**BOARD OF ZONING ADJUSTMENT
STAFF REPORT****Date: June 3, 2013****CASE NUMBER**

5832/4934

M & E, Inc.

LOCATION3240 Moffett Road
(North side of Moffett Road, 410' ± East of Smith Street).**VARIANCE REQUEST****PARKING SURFACE:** Parking Surface Variance to amend a previous Parking Surface Variance to allow gravel surfacing for a maneuvering area in an I-1, Light Industrial District.**ZONING ORDINANCE
REQUIREMENT****PARKING SURFACE:** The Zoning Ordinance requires asphalt or concrete for all parking and maneuvering surfaces in an I-1, Light Industrial District.**ZONING**

SITE PLAN

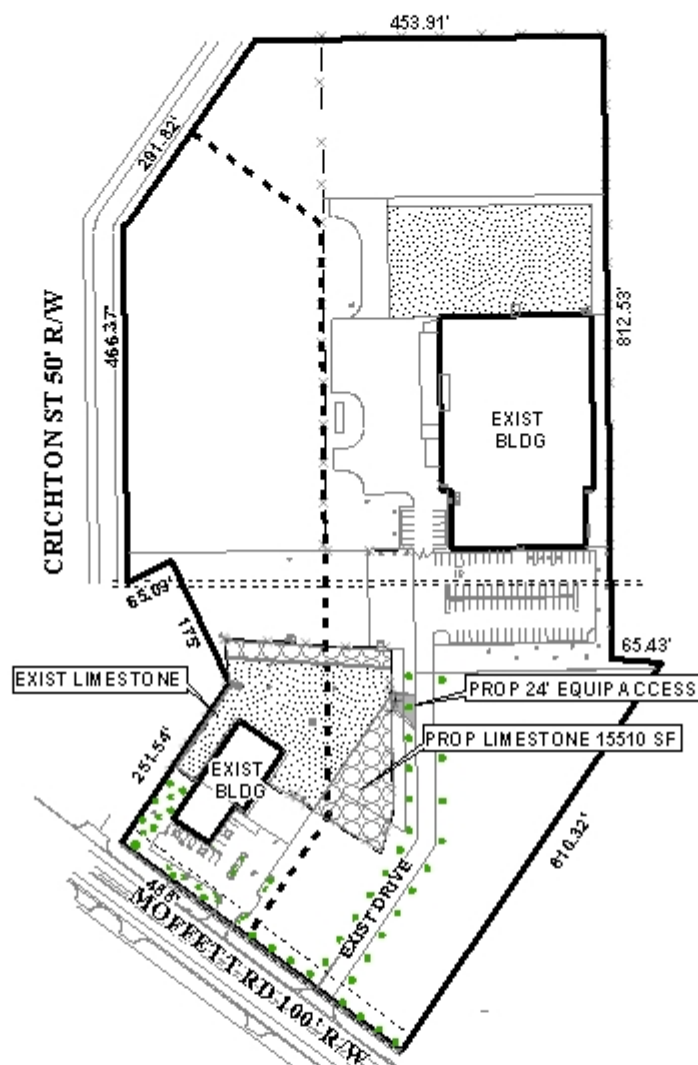
The site plan presented has deficiencies which need to be corrected on a revised site plan. The parking space requirement calculations need to be revised to indicate twelve parking spaces for office use (1/300 square feet, rounded up to twelve spaces), and one space per three warehouse employees, rounded up to two required spaces, for a total of 14 parking spaces required. The site plan should be revised to provide such parking spaces.

The site plan indicates one dumpster within the front yard and within a drive aisle. As dumpsters are not allowed within front yards or drive aisles, the site plan should be revised to relocate this dumpster to a compliant location on the site. Another dumpster is indicated to the rear of the site but without screening or a sanitary sewer connection. The site plan should be revised to indicate any dumpster on site to have the required screening and sanitary sewer connection.

A tree planting plan to cover the street frontages of both lots along Moffett Road should be submitted. As both sites are zoned I-1, only frontage trees are required.

- 1) revision of the required parking spaces calculations to indicate twelve parking spaces for office use (1/300 square feet, rounded up to twelve spaces), and revision of the required parking spaces calculations to indicate two parking spaces for warehouse employees (1/3 employees, rounded up to two spaces), for a total of 14 parking spaces required;

- 2) revision of the site plan to provide a total of 14 compliant parking spaces;
- 3) revision of the site plan to remove the dumpster from the front yard and drive aisle;

- 4) revision of the site plan to provide compliant screening and sanitary sewer drainage connections for any dumpster(s) on site;
- 5) revision of the site plan to indicate compliant over-story frontage trees for the adjacent lot to the East;

- 6) submission of a revised site plan to the Planning Section to include the above-listed revisions and any revisions required by the Administrative Planned Unit Development; and
